**LEGAL ADVERTISEMENT
HISTORIC PRESERVATION BOARD
CITY OF PORTLAND
Public comments are taken at all meetings.**

HISTORIC PRESERVATION BOARD AGENDA

**PUBLIC HEARING
104 WEST STREET**

**PUBLIC HEARING
197 SPRING STREET**

GROUND FLOOR PLAN

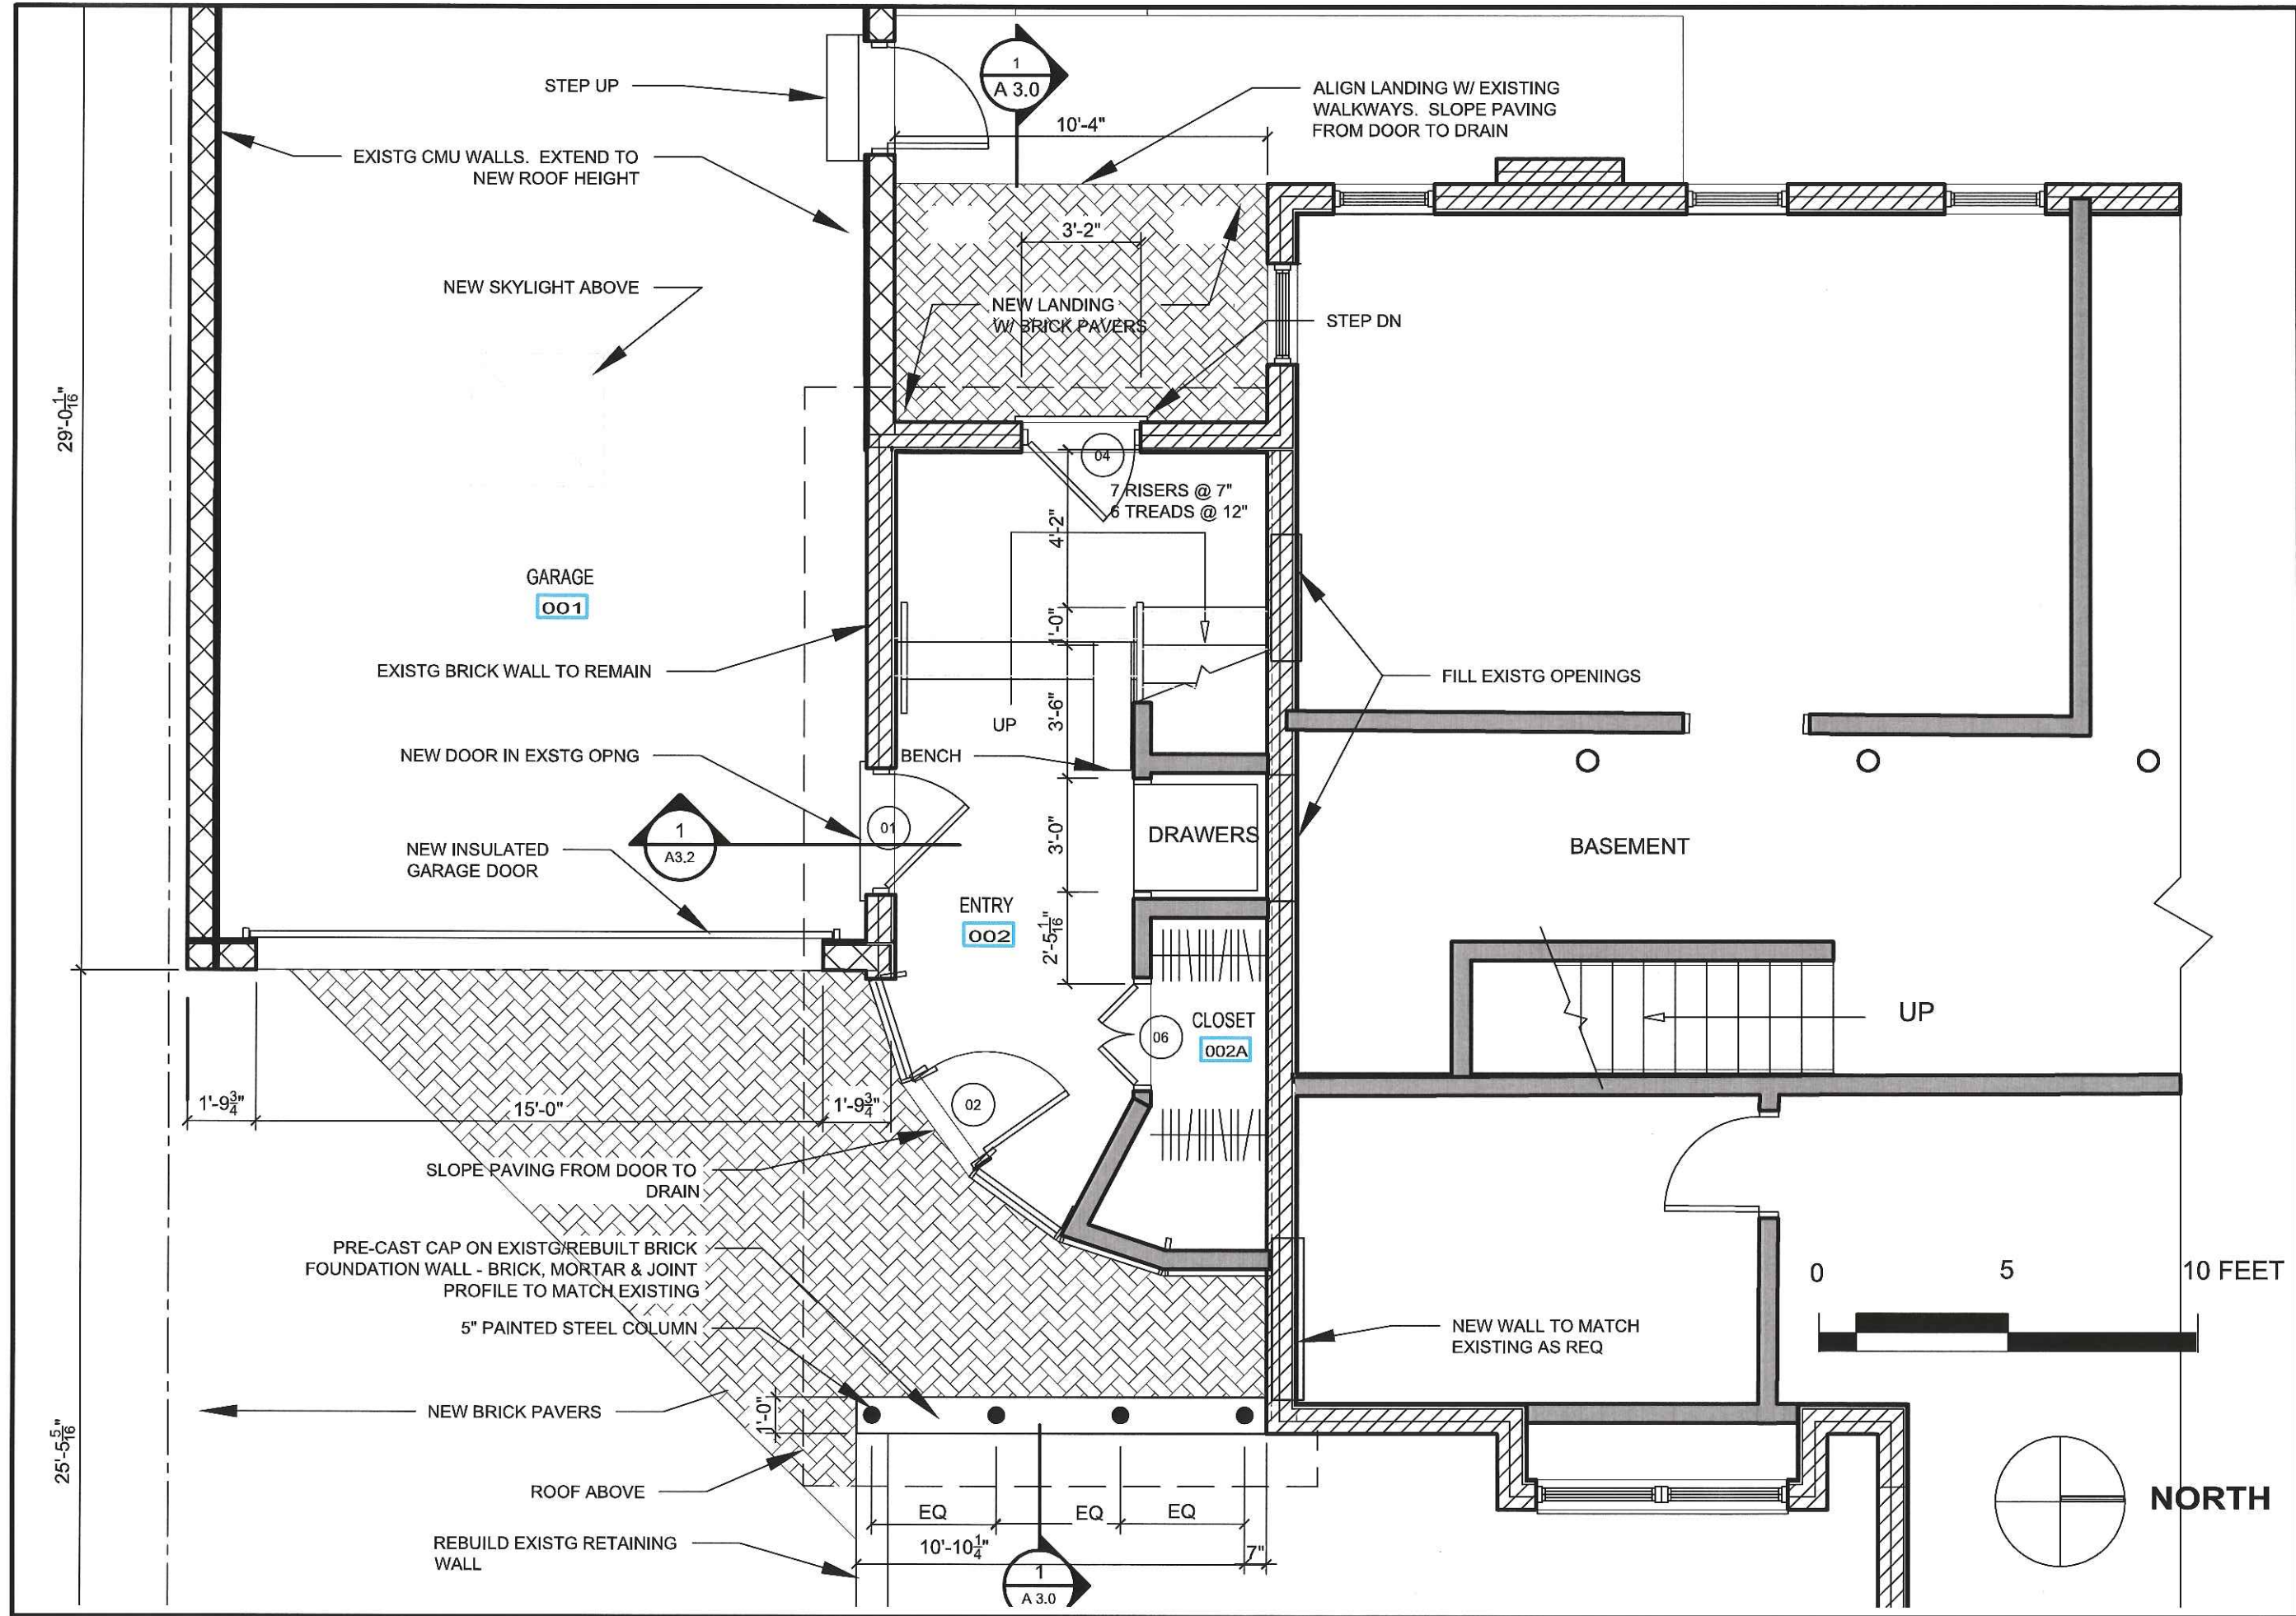
The existing rear entrance at 104 West Street provides a transitional step between the low, simple garage and imposing, traditional mass of the house. Ms. Hawkes’ revised plans again propose to give the connecting section a distinctly contemporary character, with an easier, more open and welcoming entrance. The high roof has more grounding than in early July, with more columns and a lattice “wall” between columns. The Board may wish to discuss:

- Whether the columns appear thin for their height, at 5” in diameter
- Whether larger, square columns would anchor the roof more firmly, and make for a smoother, slightly more traditional mating of columns and lattice panels
- Whether the green color of the lattice is being proposed as a new trim color for the entire house, or only for the rear entry area – and whether it relates to an existing color

Moving the lattice wall from directly over the window wall to the plane of the former front wall of the entry would provide a partial, more traditional (painted) screen over the contemporary (natural finish) window wall, except from further south on Chadwick Street – from where the tall, recessed, entry wall would be quite visible. Board members may wish to comment on the degree of visibility from Chadwick Street. At the July workshop several Board members suggested introducing more opaque surfaces for parts of the proposed entry wall, and staff wonders whether escaping light or a desire for greater privacy might motivate a future investment in adjustable window treatments (presumably on the interior) for some or all of the glass panels.

- The trellis has been moved to the outside wall, where there were formerly two columns. It consists of three panels with four (4) five-inch columns between. This responds in part to comments made during the Workshop, and creates a more traditional screen over the more contemporary entrance wall, which remains set back. The client feels that this acts as an indicator that the area behind is private and it also provides a stronger foil for the curved wall behind.

- The lattice is composed of $\frac{3}{4}$ " wide x 4" deep members, set 5 inches on center. We will bring a sample to the hearing. It will be built in mahogany and painted a dark green (similar to California Paints "Historic Colors of America" "Pointed Fir"). Painted lattice panels will also be in front of the windows above the garage on the south side. This also responds to concerns about the maintainability of unfinished mahogany.

- We would like to wait until the wall is constructed to do some mockups to determine whether the columns should be painted to match the trim or the lattice color.

- The curved entry wall will be simpler glass in custom oiled mahogany wood frames. This will enhance the expression of the curve. It also responds to the traditional practice of natural finish oak or other woods on entrance doorways, including at 104 West Street.

- The cornice on the entrance porch has been simplified. It provides similar height, proportions, projection and shadow lines as the historic cornices on the building, and was included in the Sketchup model viewed at the last Workshop. We believe that it is more appropriate to the contemporary nature of the screen wall.

EAST ELEVATION

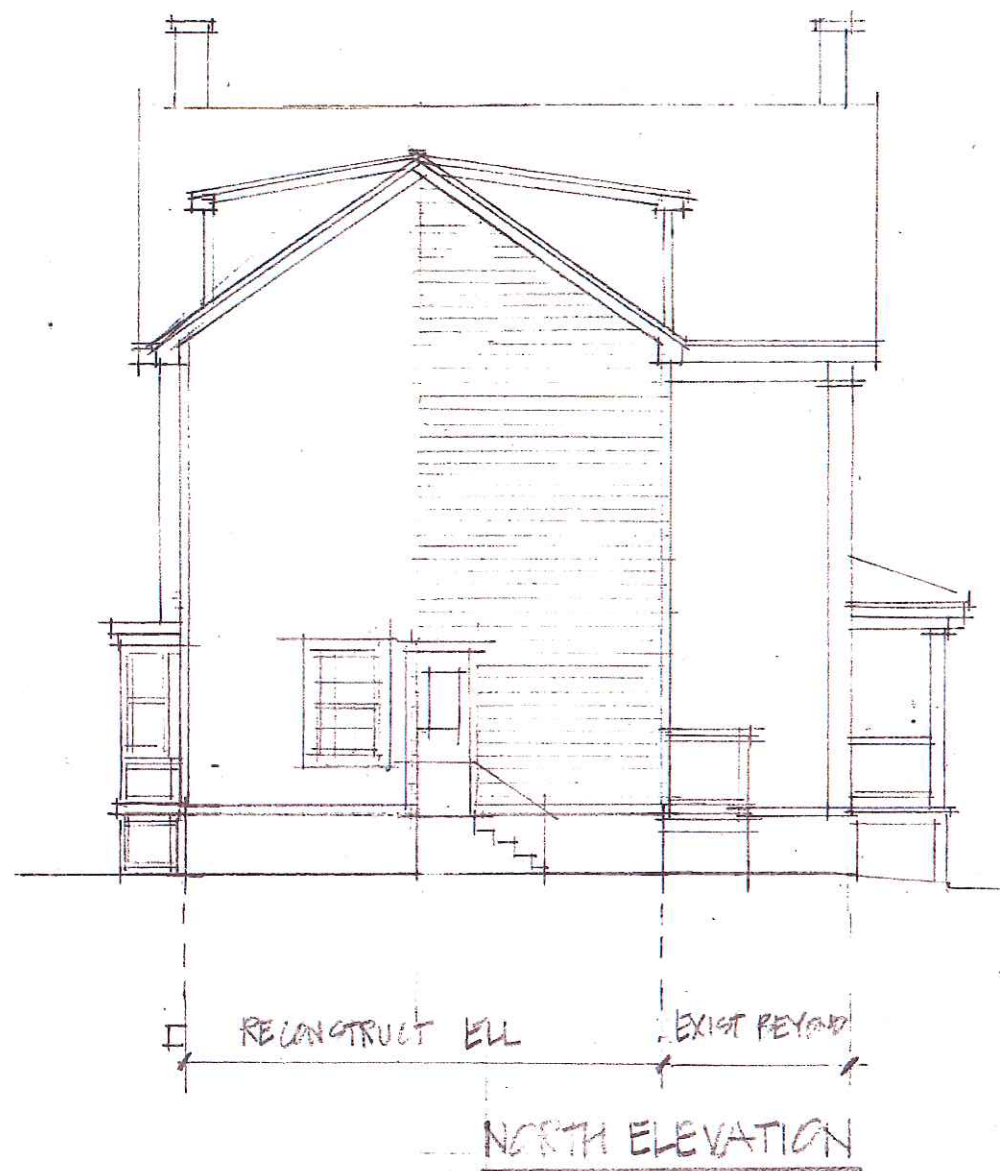
- Final specifications on the doors and windows can be reviewed by staff, assuming the Board is comfortable with the design direction shown.
- On the east elevation of the front house, Mr. Harmon has proposed adding a basement window, aligned below the upper windows. Are Board members comfortable with the absence of a partner basement window closer to the street? (On the front of the building, each bay of upper windows has a basement window below.)

- The fenestration in the proposed new ell: there are more 2/2 double hung windows, in a regular pattern
- The east dormer on the ell has been elongated like the west dormer, to run all the way to the rear plane of the main roof.
- The east bay has been completely redesigned, moved away from the intersection of the ell and the main house, and is not a recreation of the existing Italianate bay. (See architect's summary.)
- Entry porch details have been provided (west side.)

1 ELEVATION @ PORCH

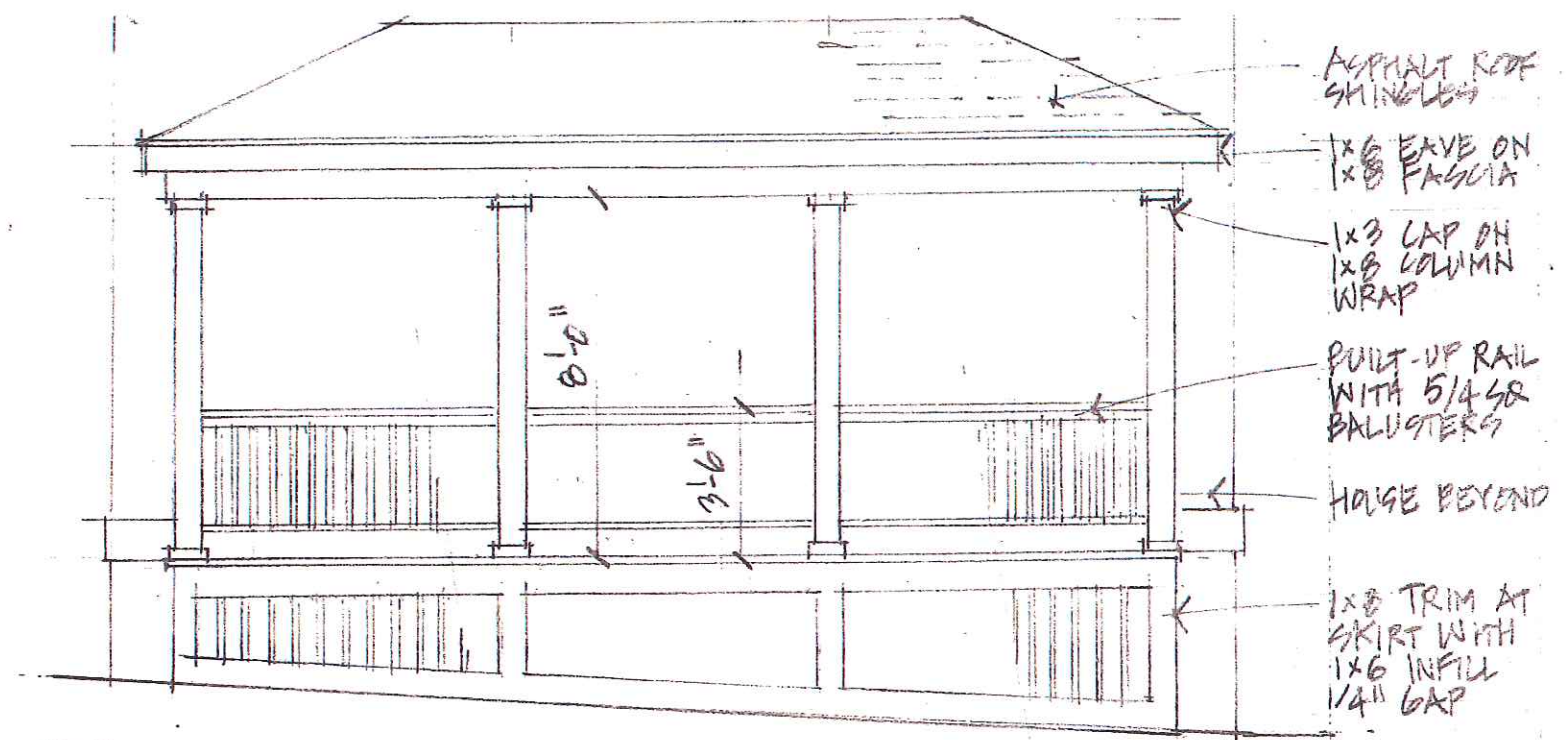
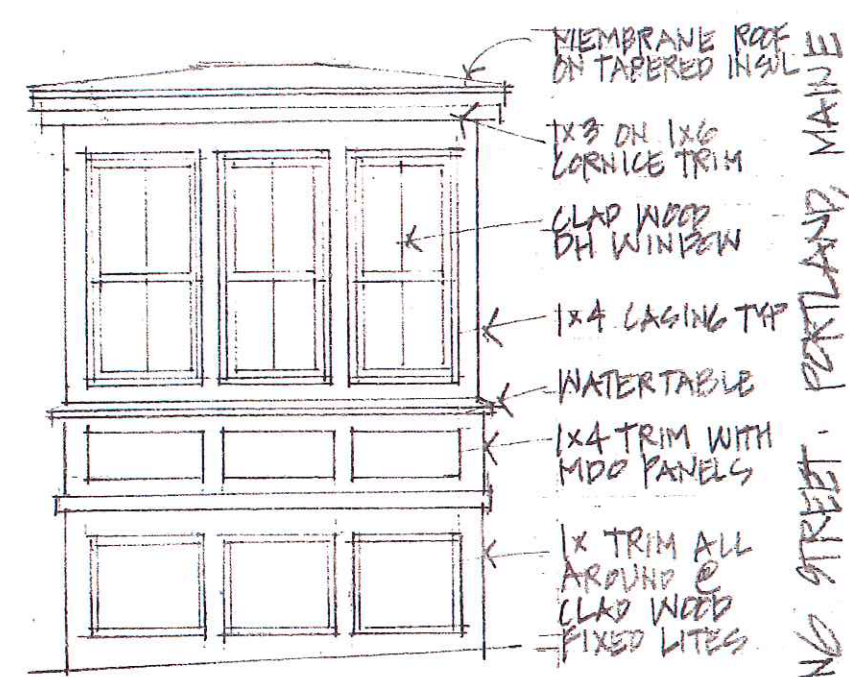
- In July several Board members seemed comfortable with extending the east dormer on the ell all the way to the main roof, like the west dormer; is this the case for the entire Board? The larger dormer would increase useable interior space, but in elevation it fills in the east roof of the ell, making the ell seem less distinct from the main block.
- Mr. Harmon has provided more detail on the west entry porch, going on the indications of the remnants visible in the existing porch and in the 1924 photo. (While the porch at 205 Spring Street is similar in concept, it has some details that are clearly later the Greek Revival beginnings of the house.) If the proposed porch looks generally compatible to the

Board, but further scrutiny of details is needed, members have the option of asking staff to review final details of the cornice, columns, bases and caps, railings, etc.

- Remove and replace the existing entry porch. The original entry appears to have been a side porch with boxed wood columns, simple capital, and sloped shed roof. The current porch is a hodge-podge of concrete steps and landing, hood overhang, and wood rails, all added at different times, in no uniform style or consistency of materials. We propose to recreate the original entry porch form and match the detailing as far as can be determined from the 1924 photo (simple boxed columns, square baluster rail, wood steps). The existing entry door pilasters remain and will be repaired, with a single leaf door and sidelight installed within the original opening. As the porch soffit is unknown, we propose edge & center beadboard, as would be typical of the neighborhood. All wood will be painted.

Figure 1-1: Section at Building #12 and proposed new connector road.

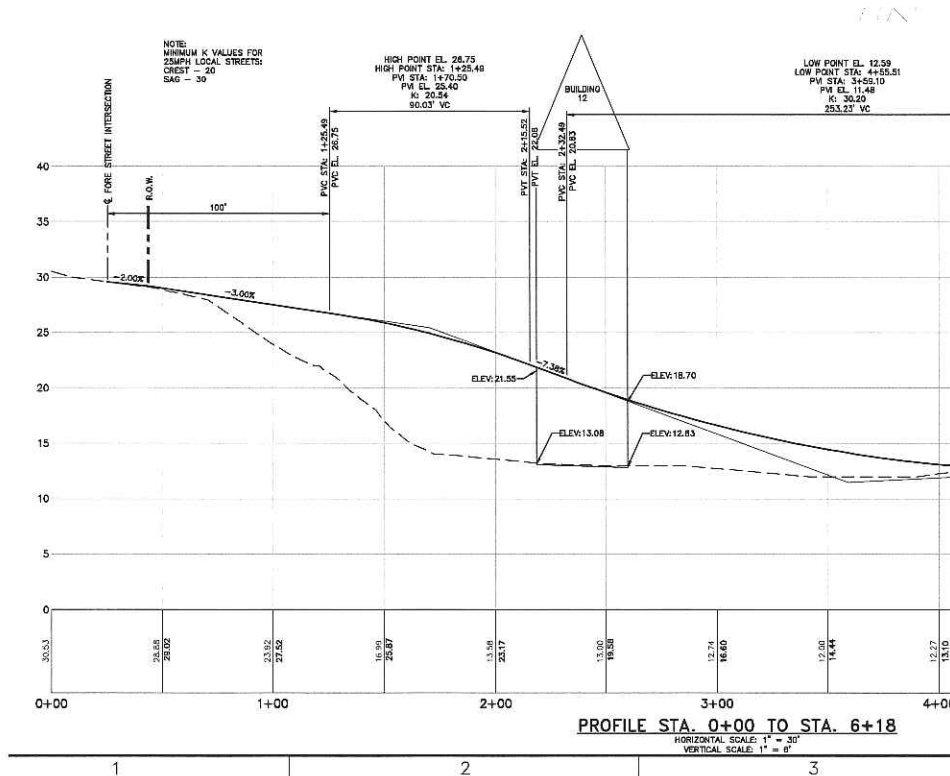
As noted in the introduction to this report, development plans for the historic core of 58 Fore Street are still very conceptual and are being developed in conjunction with the applicant's larger master planning exercise. While the overall master plan is expected to be presented to both the Historic Preservation Board and Planning Board in the fall, the applicant has asked for an opportunity to continue the discussion begun in June and to present a revised development program for the Board's input. As the location of Building 12 is a threshold question that materially impacts other aspects of the planning process, the applicant is particularly eager to learn whether the Board is generally supportive of its new location as currently proposed.

The grade changes at this specific location are best seen in the profile image prepared by Woodard & Curran (Civil Engineers), for the City of Portland, dated February 26, 2016. Here the significant grade from the finished floor elevation of Building #12 of 12.83' and 13.08' (Approx. 13.0') up to the nearby connection at Fore Street at elevation 29.0' create a challenging situation for Building #12, once the new connector road is constructed. As shown in this profile section, the new roadway would obstruct public view of a large portion of the first floor of Building #12, with 8.47' and 5.87' respectively, being below the plane of the new roadway. In essence, this necessary infrastructure connection would "bury" much of the first floor of this building, in the new higher grade, required for the roadway. The result of this roadway intervention would be the uncomfortable relationship of Building 12 to its new surroundings on the west side.
